POST TENDER ADDENDUM

JLG 16098 Bottineau Ridge II Apts

RE: post tender addendum 02

Issued: March 16, 2018

SHEET
S405
FRAMING DETAILS

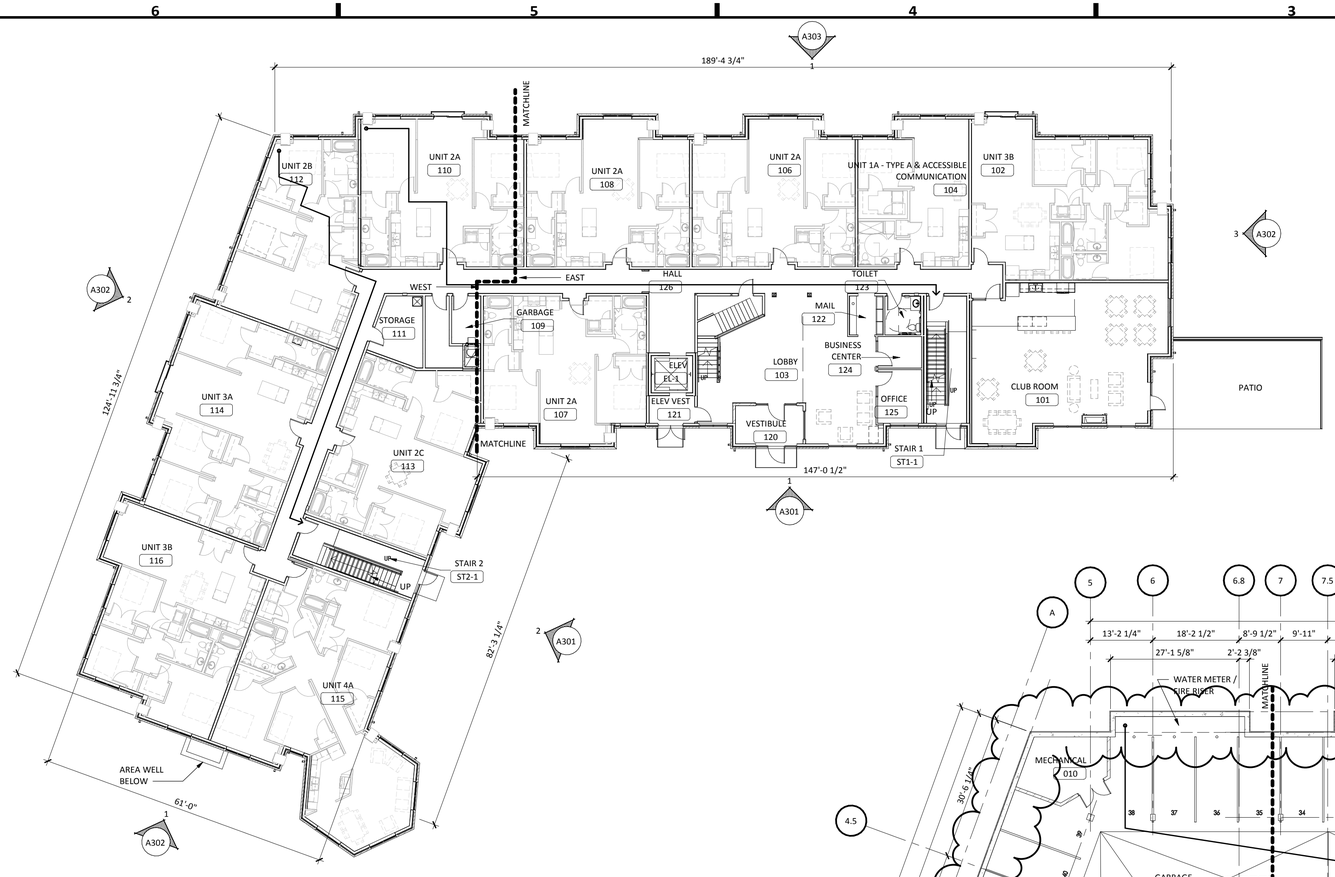
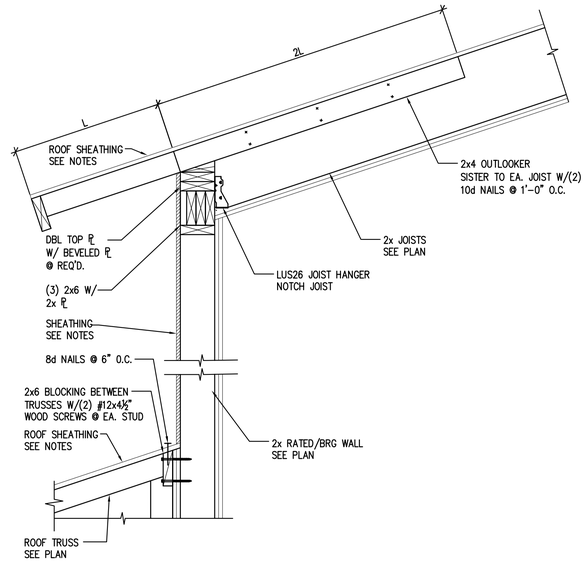
- Details updated for CIP foundation walls
16. S405 FRAMING DETAILS – See attachment.
    - Details updated for CIP foundation walls
17. A200 OVERALL GARAGE & FIRST FLOOR PLANS – See attachment.

1 A200 GARAGE FLOOR PLAN - OVERALL

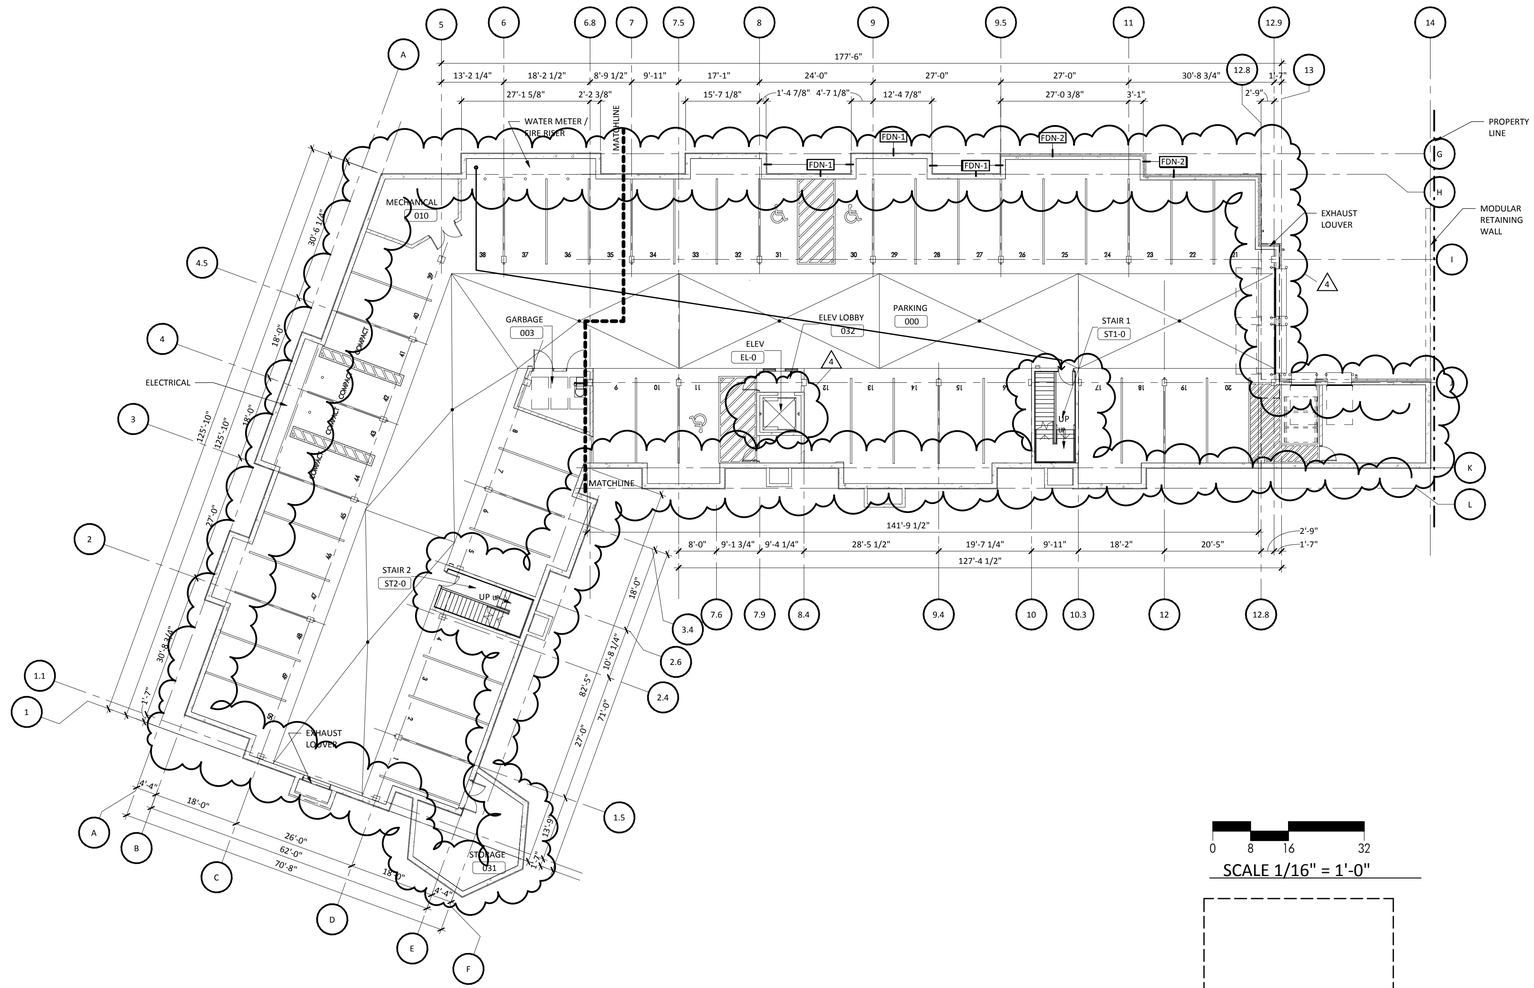
- Detail 1/A200, revised foundation, stair and elevator enclosure wall types.
18. A210A GARAGE PLAN – WEST. See attachment.
    - Detail 1/A210B, revised foundation and stair enclosure wall types, and revised west area well.

DATE 12/04/2017
PHASE 100% CDs
PROJECT 16098
SHEET A210B
GARAGE PLAN - EAST

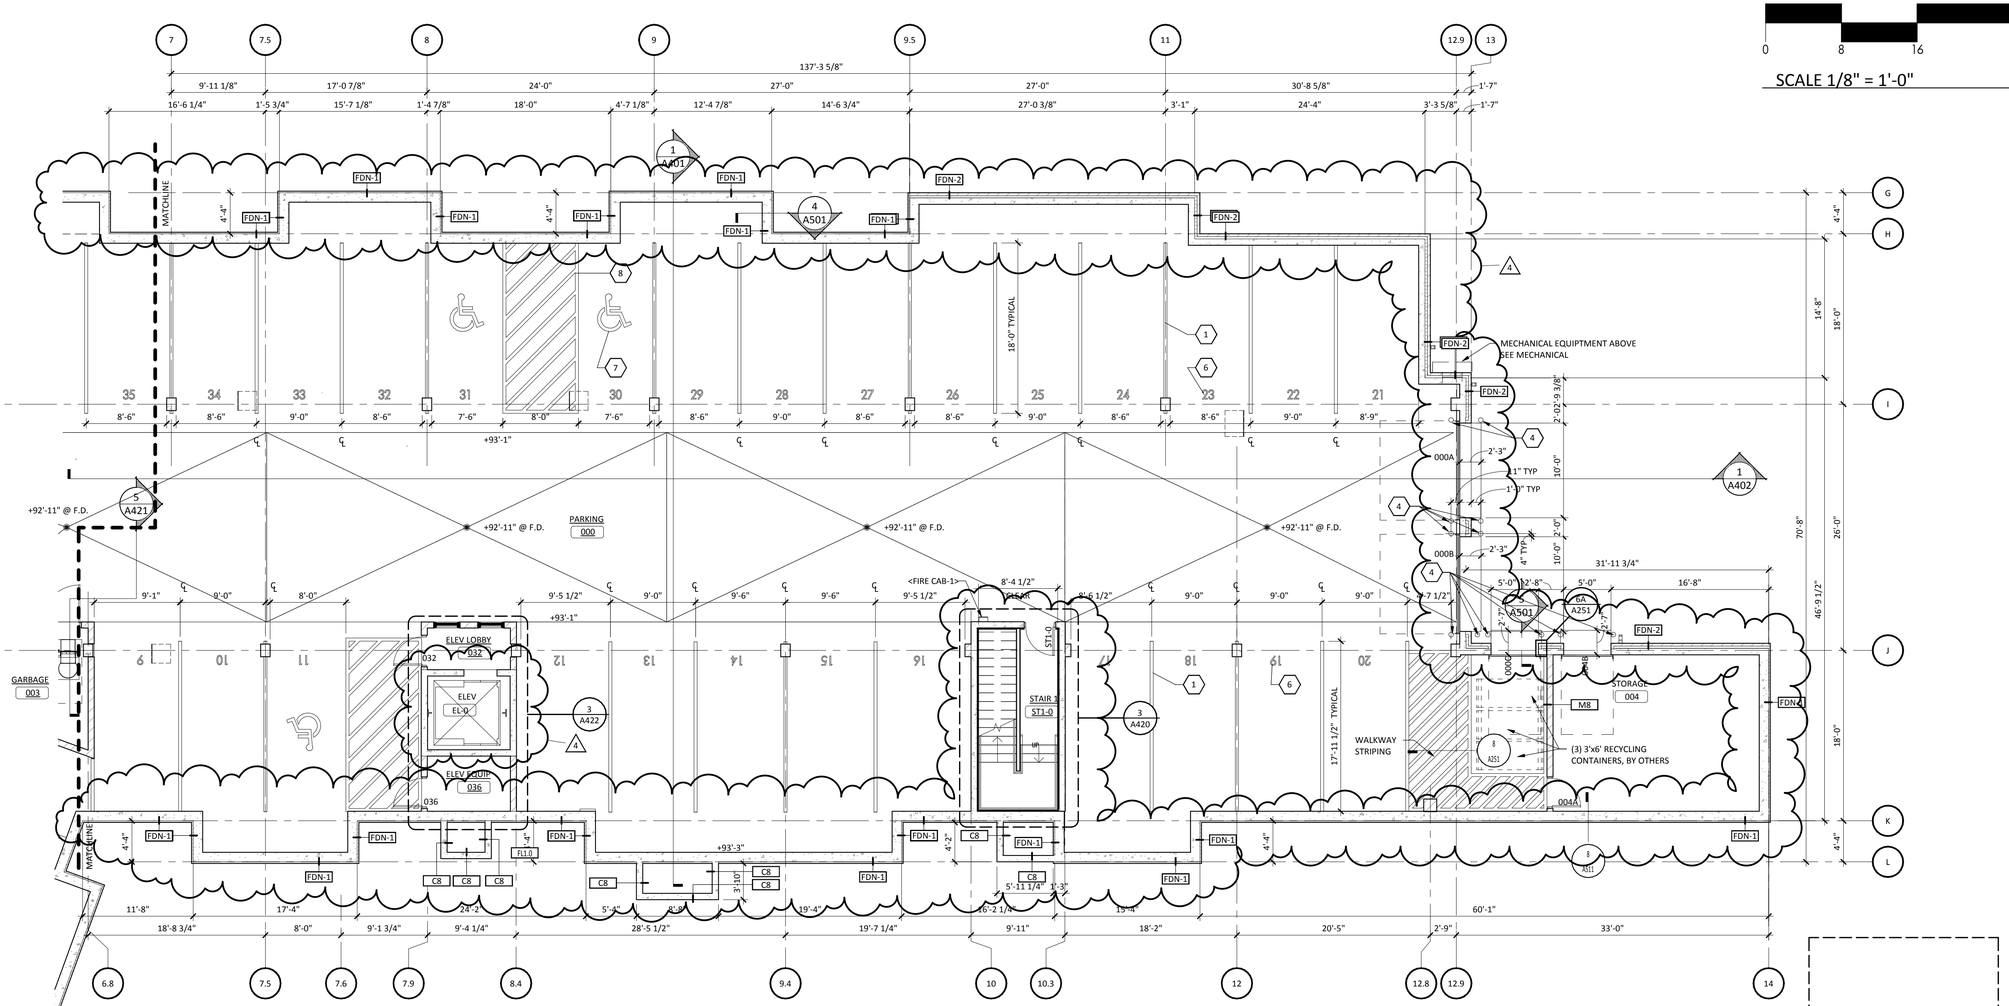
19. A210B GARAGE PLAN – EAST. See attachment.
    - Detail 1/A210B, revised foundation, stair and elevator enclosure wall types.
20. A220 UNIT PLANS. See attachment.

1 A220 UNIT PLAN - 1A
SCALE: 1/4" = 1'-0"

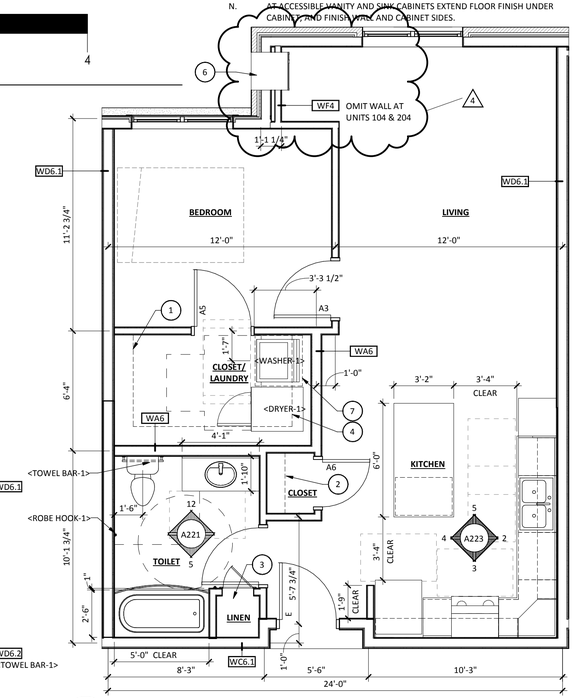
- Detail 1, 2 & 3/A220, revised furring wall at a/c units.
21. A221 UNIT PLANS. See attachment.
    - Detail 1 & 2/A221, revised furring wall at a/c units.

1 / A222 UNIT PLAN - 3B
SCALE: 1/4" = 1'-0"

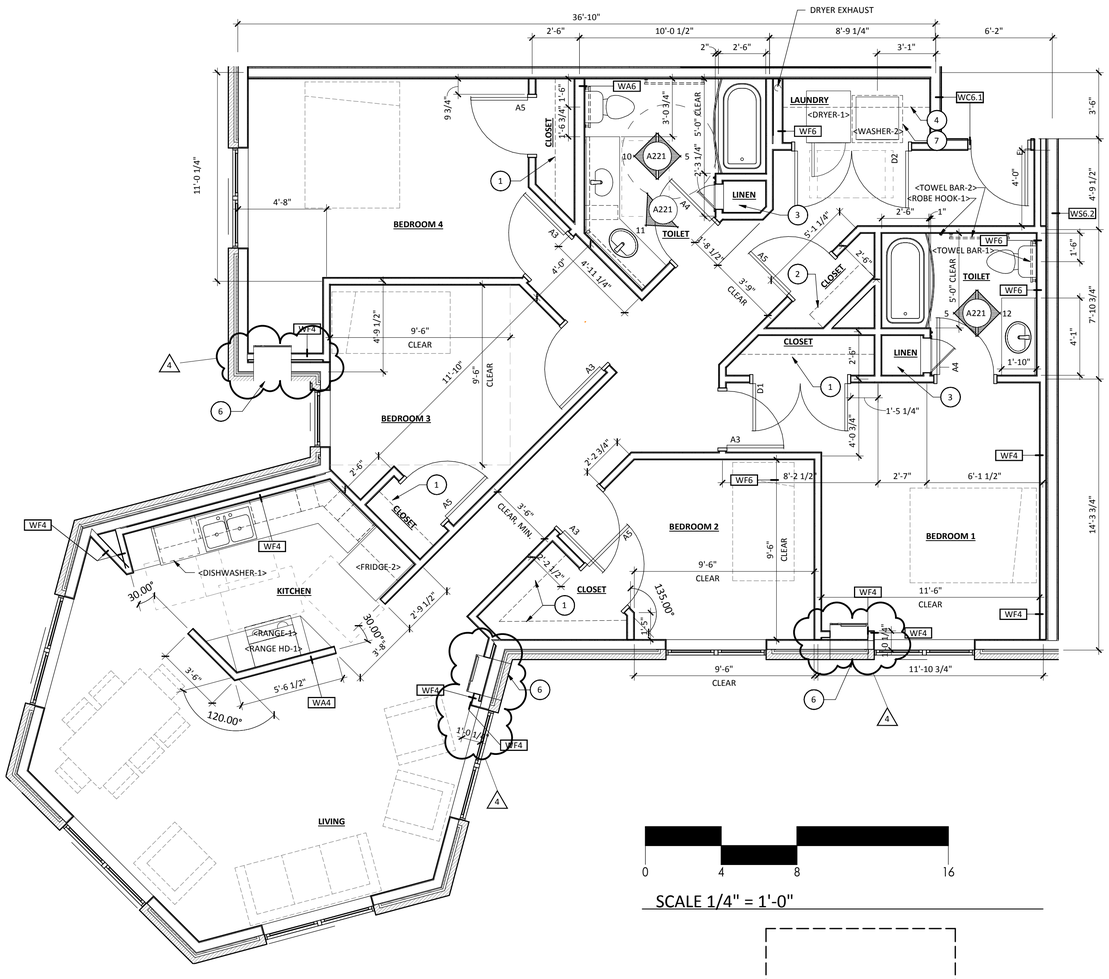
22. A222 UNIT PLANS. See attachment.
    - Detail 1 & 2/A222, revised furring wall at a/c units.
23. A223 UNIT PLANS. See attachment.
    - Detail 1/A223, revised furring wall at a/c units.

DATE 12/04/2017
PHASE 100% CDs
PROJECT 16098
SHEET A224
TYPE-A UNIT PLANS

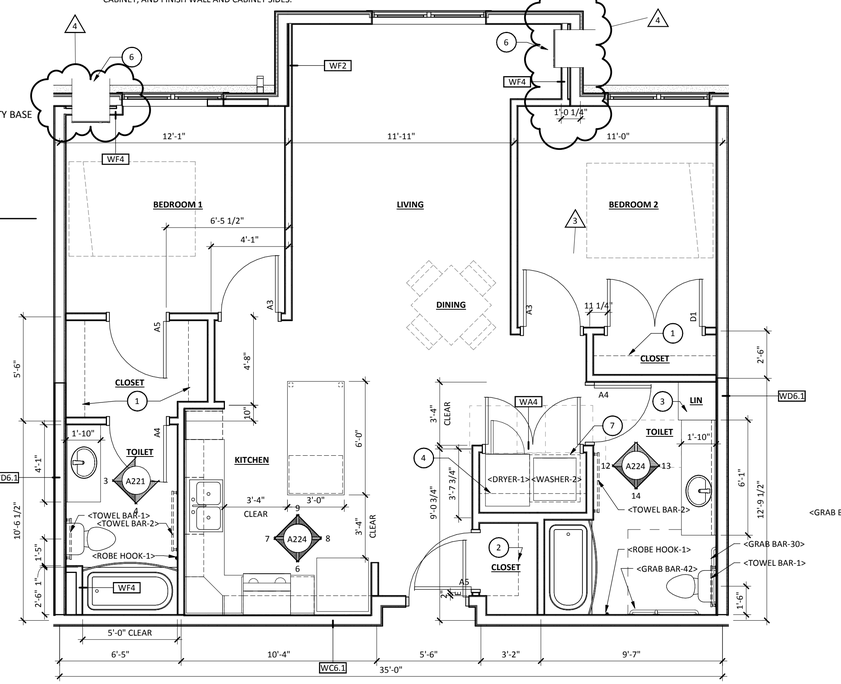
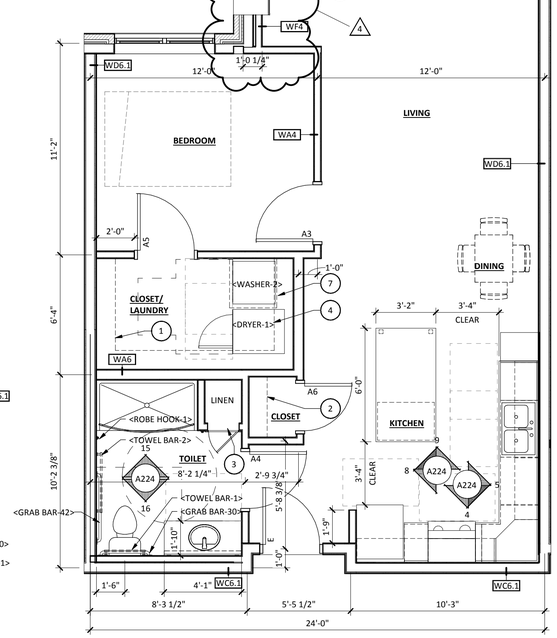
24. A224 UNIT PLANS. See attachment.
    - Detail 1, 2 & 3/A221, revised furring wall at a/c units.
25. A250 DOOR SCHEDULE & GLAZING ELEVATIONS. See attachment.

DATE 12/04/2017
PHASE 100% CDs
PROJECT 16098
SHEET A251
DOOR DETAILS

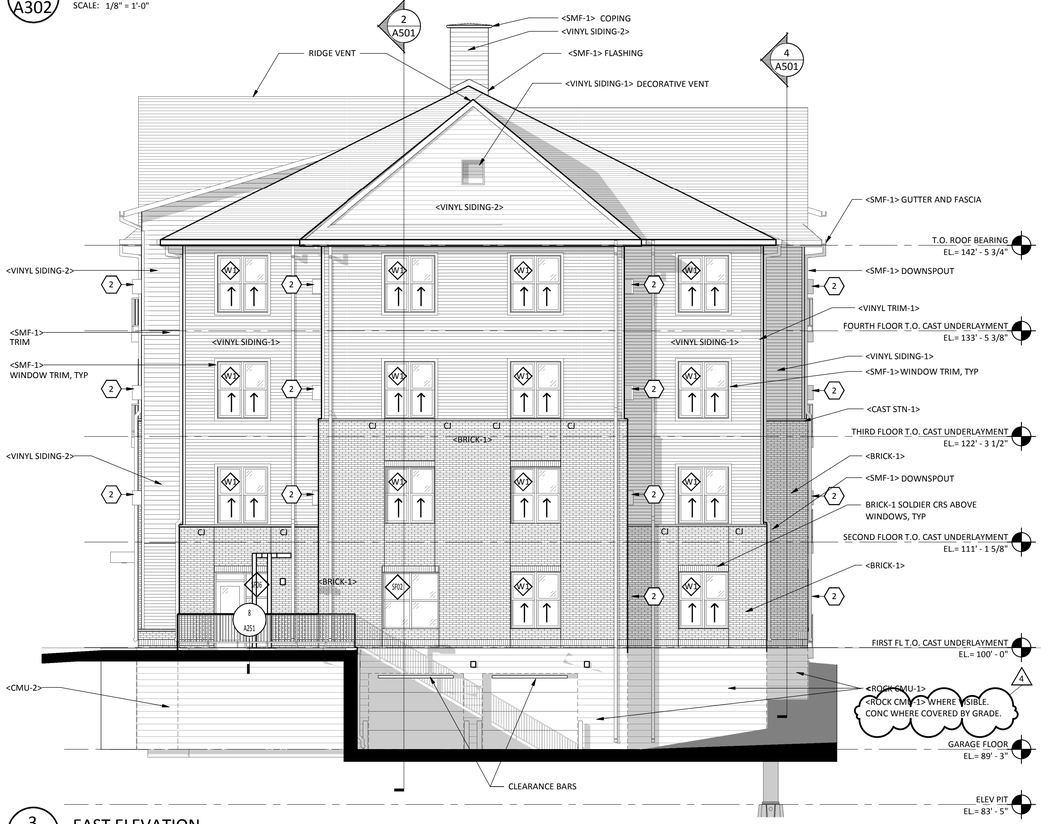
- Window Types, added Window Type 8.
26. A251 DOOR DETAILS. See attachment.
    - Details 2D, 3D, 6A & 6B/A251, revised foundation wall to concrete in lieu of CMU.

3 / A302 EAST ELEVATION
SCALE: 1/8" = 1'-0"

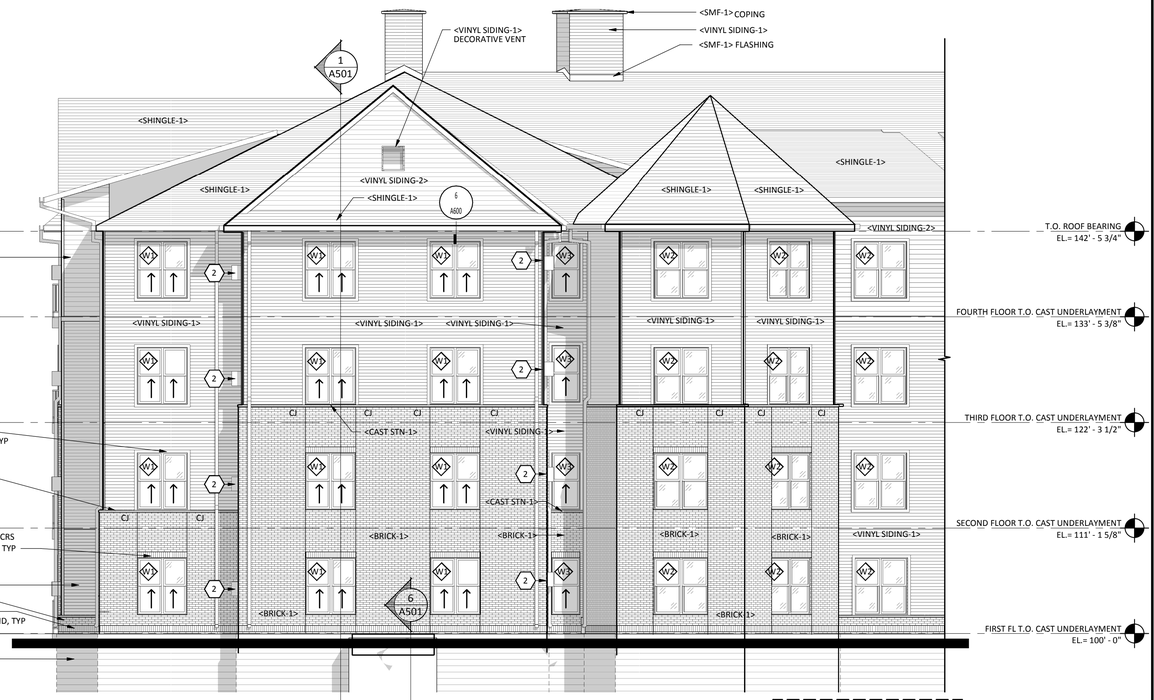
27. A302 EXTERIOR ELEVATIONS. See attachment.
    - Detail 3/A302, revised foundation wall below grade keynote from "CMU-2", to read "CONC".

1 A420 SECTION AT STAIR 1
SCALE: 1/4" = 1'-0"

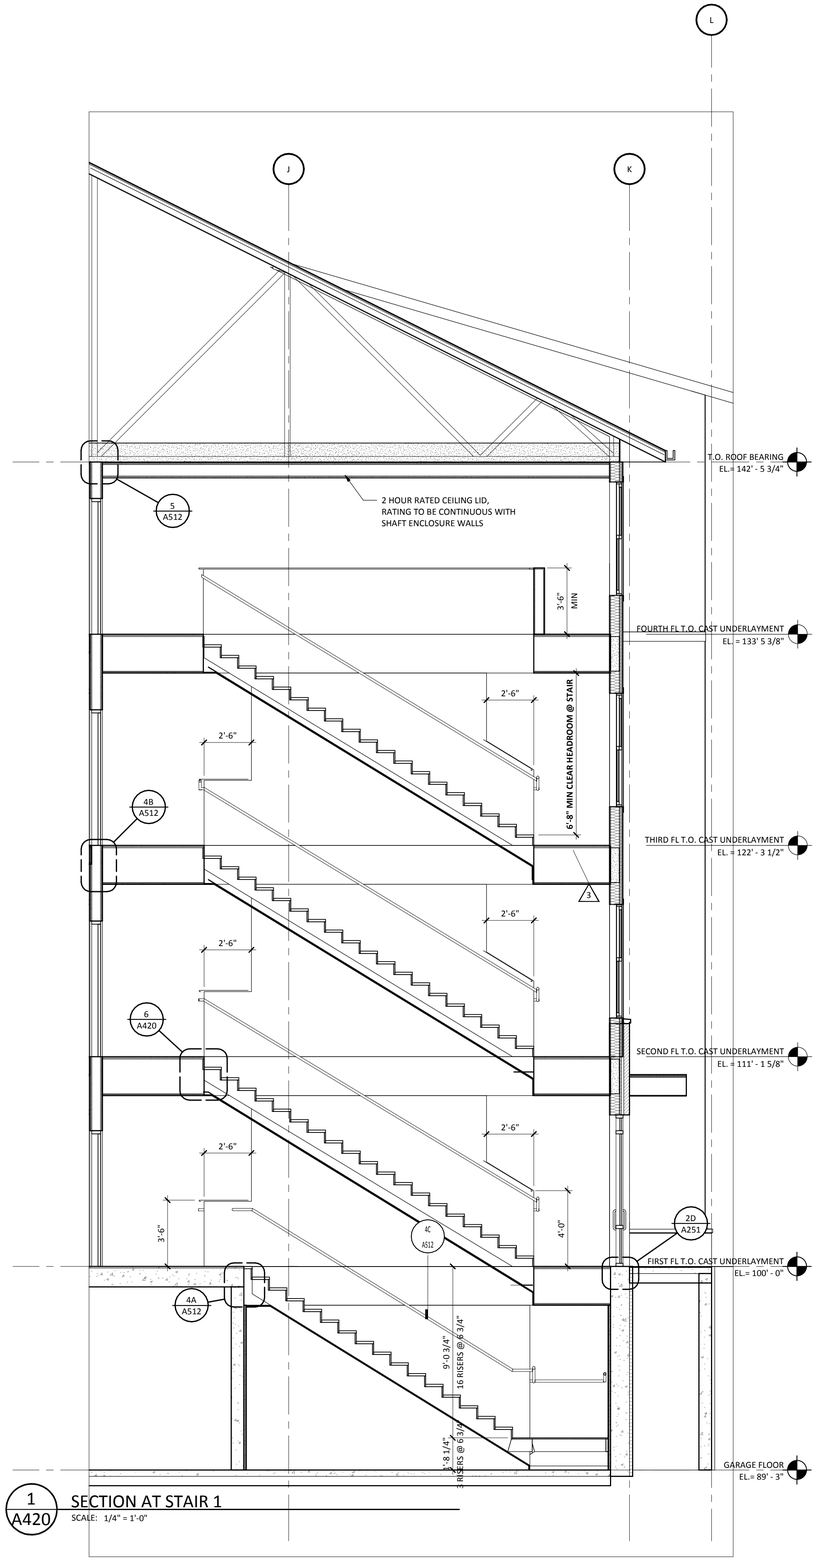
- Detail 1 & 3/A420, revised enclosure walls from CMU to concrete, add window type “8” at two locations.
30. A421 VERTICAL CIRCULATION – STAIR 2 – See attachment.
